**ORDINARY MEETING
OF
KOATA HĀTEPE | REGULATORY PROCESSES COMMITTEE
AGENDA**

Time: 9:30am
Date: Thursday, 1 December 2022
Venue: Ngake (16.09)
Level 16, Tahiwi
113 The Terrace
Wellington

Business	Page No.
1. Meeting Conduct	5
1.1 Karakia	5
1.2 Apologies	5
1.3 Conflict of Interest Declarations	5
1.4 Confirmation of Minutes	5
1.5 Items not on the Agenda	5
1.6 Public Participation	6
2. General Business	7
2.1 Ngaio and Aro Valley Transitional Cycleway Traffic Resolution Hearings	7

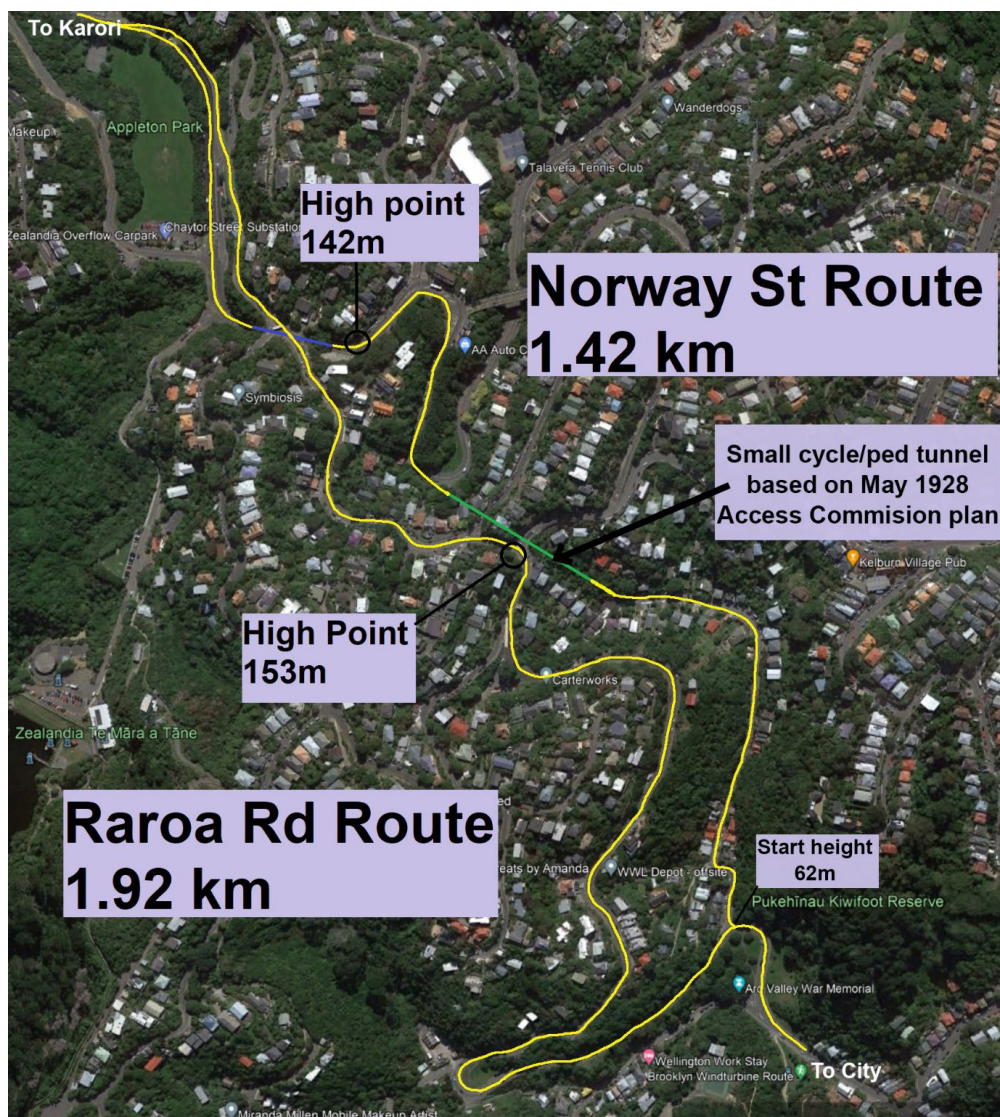
The parking survey was based on existing residential use without consideration for greater intensification as a result of the Government changes that permit three units per site as of right, creating more parking demand, and greater traffic through to Karori.

Raroa Road and Karori are zoned Outer Residential in the operative district plan, thus allowing for two units per site and up to two storeys height as of right. In the new proposed district plan, these areas are zoned Medium Density Housing, now allowing for three units per site and up to three storeys in height. ***New units that have been developed in Raroa Road over the last 10 years with off-street parking have not meet the occupants' demand as witnessed by the number of vehicles parked on the road in front of these new units.***

It is apparent that those involved in the cycleway design were not aware of the plans that have been on the Council books since 1928 that creates a tunnel from Norway Street through to Glenmore Street. This has been seriously proposed and examined several times by the Council for trams and other vehicles (1930s through to 1950s). In the past this was deferred awaiting greater demand. There is now practical justification for a smaller pedestrian/cycle/micro vehicle tunnel. This elegant solution will provide a better route for cyclists and will provide greater alternative access for walking and better access to bus services on Glenmore Street. Norway Street being a no-exit residential street has low vehicle numbers so would not require dedicated cycleway marking or parking loss.

Traffic calming flower beds in the heart of Aro Valley

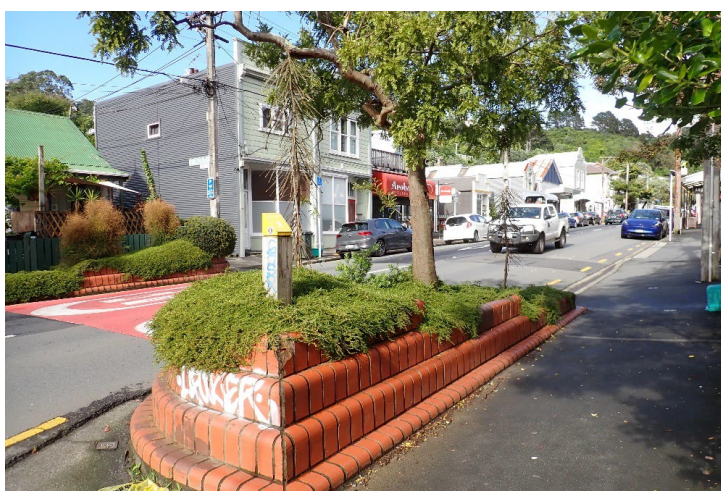
These were created some years ago for traffic calming purposes.

The plants are mainly our attractive natives and the planter boxes now contain mature trees and ground covers. It would be a tragedy to remove this attractive vegetation which defines the shopping centre and enhances the atmosphere of the Aro Valley so the cycle lanes to other suburbs can take over and occupy the road here instead.

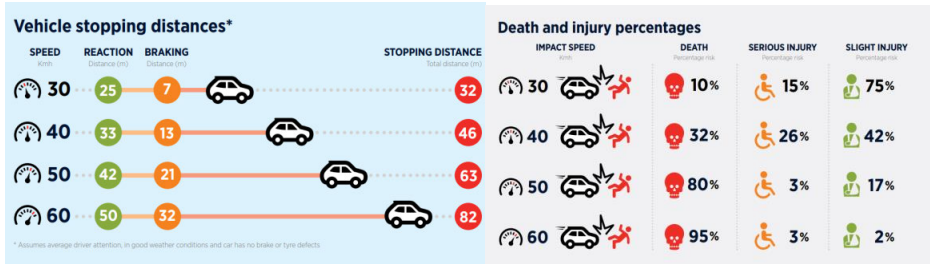
U-turns on Kenya Street. The proposal does not seem to have considered that by having parking on only one side of the road, it will mean vehicles travelling from the Ngaio end, will have to cross the road to find parking spaces. Drivers would have to either perform a U-turn or a three-point turn on Kenya St, or drive to the Kenya St/Ngaio Gorge Road intersection and turn into Trelissick Crescent and then back onto Kenya Street, to head north. Also, everyone parking on Kenya Streets west side but who want to head south will either have to use the corner of Kenya Street/Crofton Downs, by the crossing or the roundabout at Waikowhai St/Ottawa Road, or carry out a U-turn.

Performing a **U-turn in 50km./hr speed zone is dangerous**, and carrying out a U-turn or three-point turn will likely require vehicles using the cycle lane and then again in the opposite shared lane, potentially very dangerous and putting cyclists at risk.

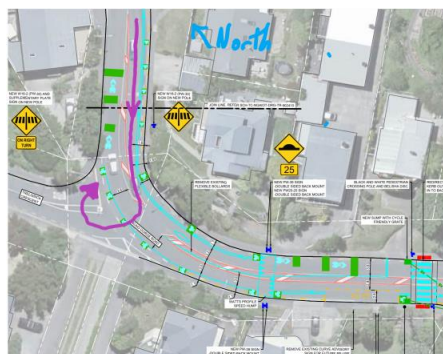
The road design and visibility at the three bends at the top of Kenya street is unsafe for speeds greater than 35 km/hr. The Road Code states that drivers should drive at a speed that they can stop within the length of the clear visibility. So, with no more than 35 meters of visibility, vehicles should not be travelling at more than about 32km per hour. (from Auckland Transport Road Safety and Safe Road Programme).

Below is a graphic for the three corners. The driver visibility is shown by the green triangle, being what the driver of the blue vehicle will be able to see, out to about 30 metres ahead of them. The red graphic represents what could be a stationary vehicle, pedestrian, cyclist, truck, etc. Vehicles travelling at more than 30kphr and needing to urgently brake, will travel 25 metres in their reaction time and another 7 meters in braking. This clearly shows that to be safe, vehicles travelling around these corners **must not be going more than 30 or 35 kms per hours**.

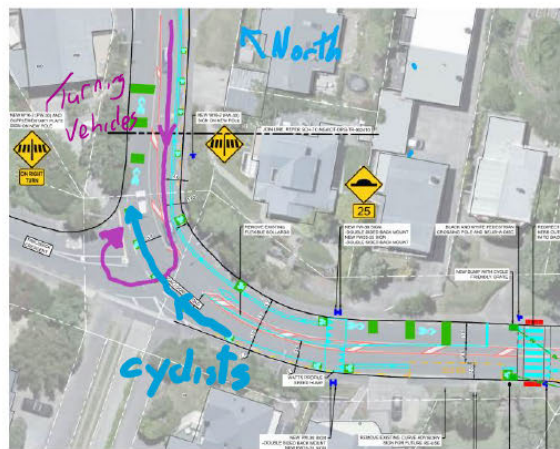
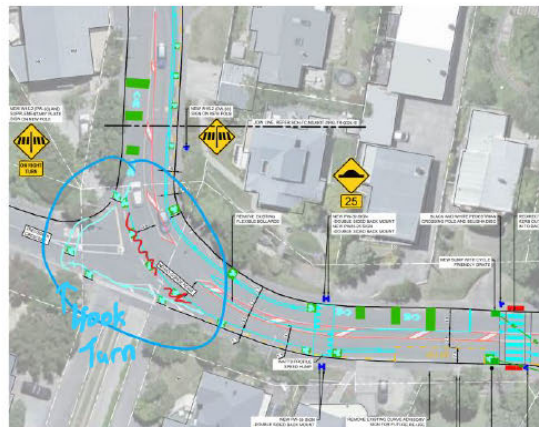
The Ngaio Connections proposal to remove the 59 carparks on the east side of Kenya street will mean a significant increase in vehicles from north/Ngaio end into Trelissick Cres and returning onto Kenya Street. The Kenya Street traffic lane on the approach to this intersection is to be narrowed to allow for the cycle lane. Also, the white diagonal lines inside the from centre line will be removed. It is a difficult and dangerous corner, as it is below the crest of the hill. The new speed humps will slow traffic, however the turning traffic will cross over the cycle lane for cyclists heading north. Drivers will have to be very careful and aware of traffic coming at them over the crest, (plus the traffic from behind) and cyclists also coming over the crest before crossing their turning path. Extremely dangerous.

For cyclist safety we suggest at this intersection, the northbound cycle lane be directed first down Trelissick Crescent, make a hook-turn and then take a left turn into Kenya St when clear.

Alternate recommendation

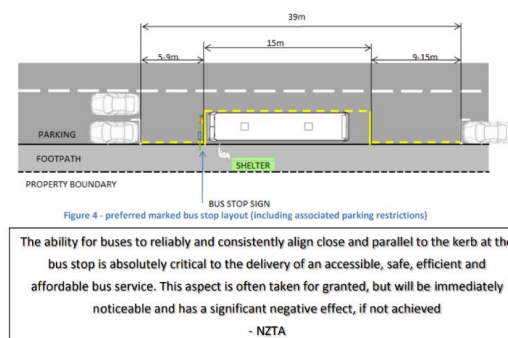
Issue 3 Bus stop at 52 Kenya Street does not allow space for buses to fully park off the main traffic shared lane

- 2.2 Do not remove the four unrestricted carparks at 48 – 54 Kenya Street.
- Extend the no stopping zone by removing one more carpark outside 52 Kenya Street
 - Extend the no stopping zone by including the driveway at 50 Kenya Street.

The no stopping zone would be 33m metres long, not quite the NZTA preferred length, but more than twice as long than as present and it saves three of the necessary on-street carparks.

Why stage an interim plan?

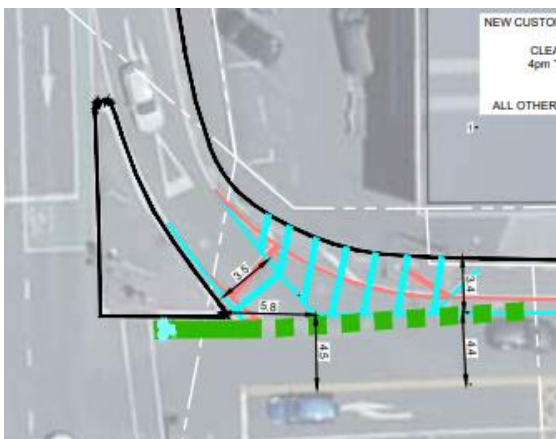
It is repeatedly noted that this proposal is for an interim design. Why does it then need to be staged itself? It ends up creating interim interim plans.

Capacity to do the work is limited so why is this plan requiring more expense for what is already going to be replaced? The current proposed plan will result in at least 4 rounds of construction before the final design is put in.

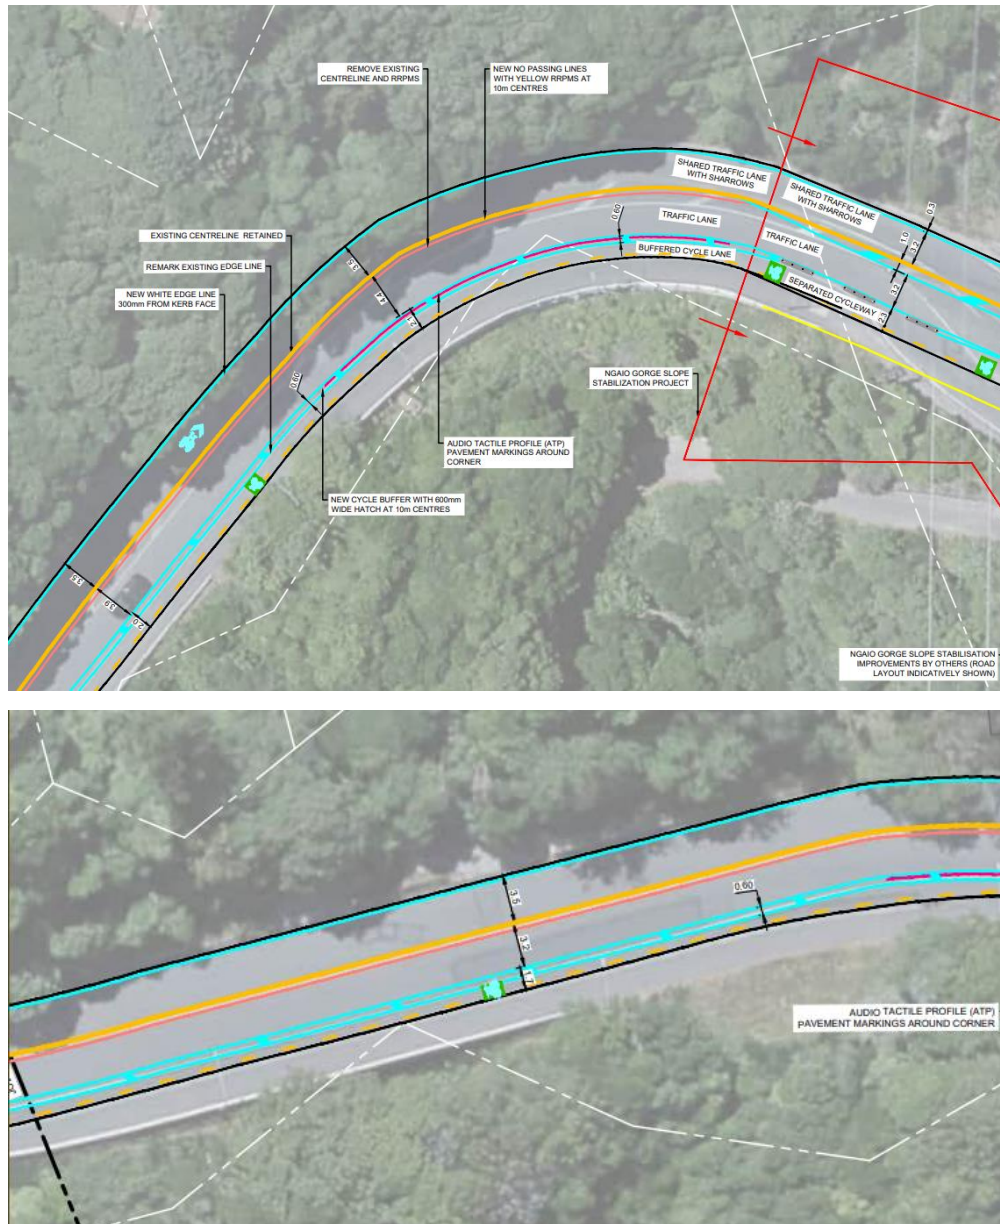
If the parking must stay then the speed limit MUST be reduced to 30kph. This will have a massive impact on the safety of mixing unprotected road users with general motor vehicle traffic. It will also have a minor impact on large commercial vehicles as the stretch most commonly used by them stops at around the oil tanks.

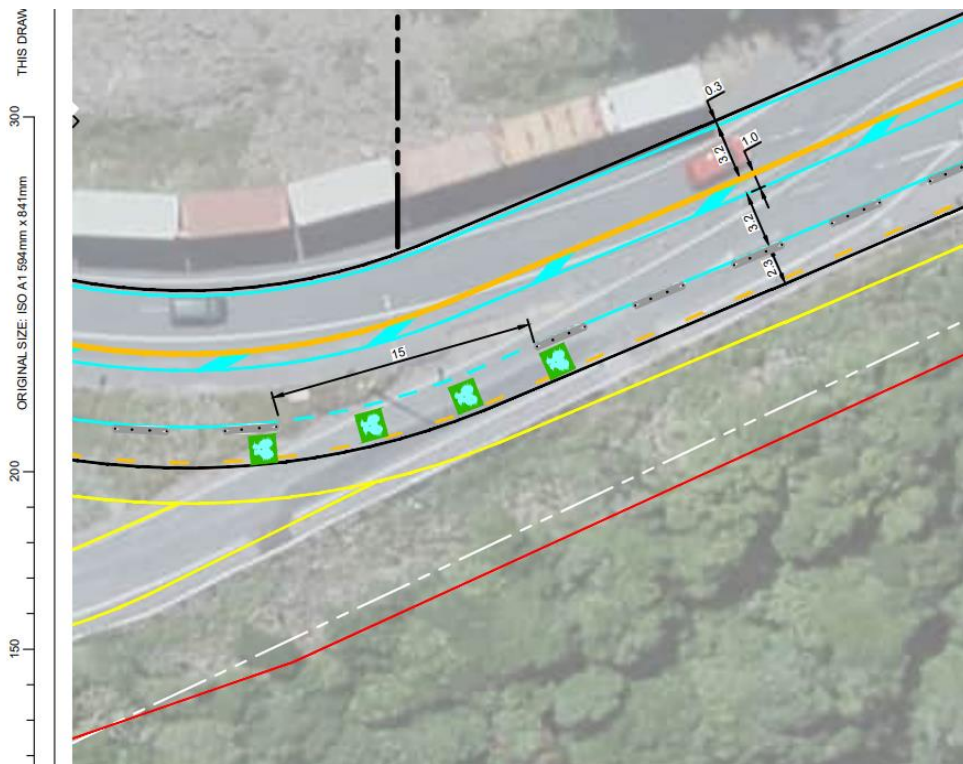
In all the downhill sections it is expected that cyclists will somehow always be able to do 50kph. This is unreasonable at best and actively dangerous at worst. Many less confident cyclists will not feel safe going such speeds with little to no protection, and even confident cyclists will have to actively pedal hard to reach such speeds on all but the core section of Ngaio Gorge.

What will, and already does happen, is that drivers will tailgate cyclists and make dangerous overtaking attempts. On top of this the parking will obstruct the view of cars exiting driveways into a narrow roadway.

If micromobility users must share the lane with general motor vehicle traffic then the speed limit **MUST** be dropped to 30kph. This will encourage less confident cyclists to try it out, improve the safety of drivers exiting driveways, make cycling more pleasant, and reduce the roadway noise for nearby residential properties from vehicles accelerating hard.

Parts of the cycleway are so absurdly narrow as to not exist

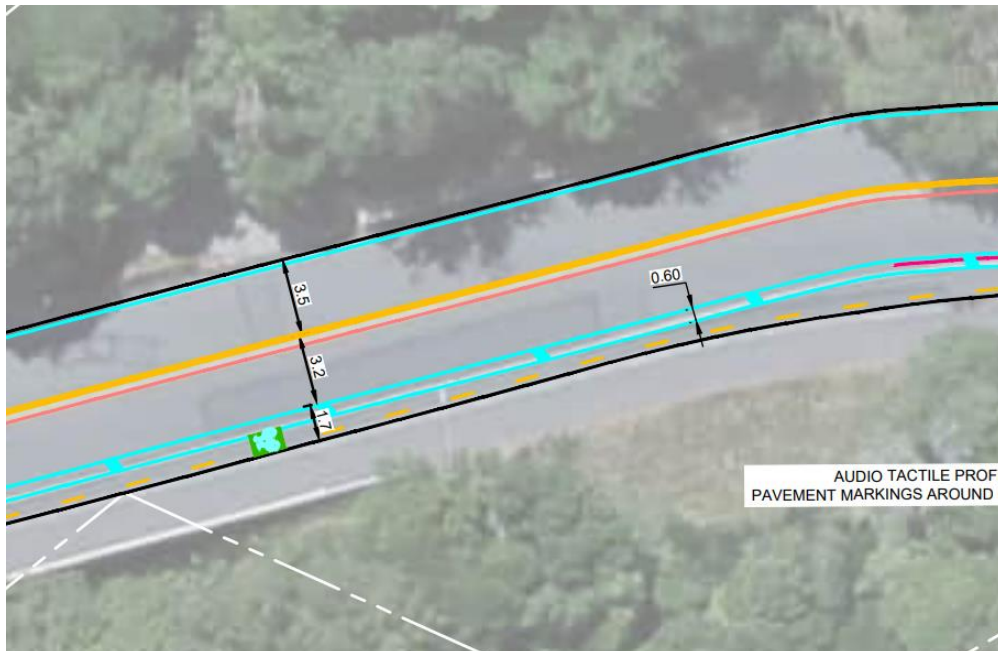
Parts of the proposed cycleway are so narrow that it becomes a sick joke that someone thought they would be safe and appropriate. The section proposed below has a nominal value of just 1.1m which seems reasonable at first glance. However that width includes the edge of the road and the gutter. Neither of which are safe for use. The edge of the road where the asphalt meets the gutter has a rough and carrying drop from one surface to the other. And the gutter is steeply angled to the gutter wall compared to the main roadway.

On top of that you will have traffic less than 60cm away zooming by at 50kph.
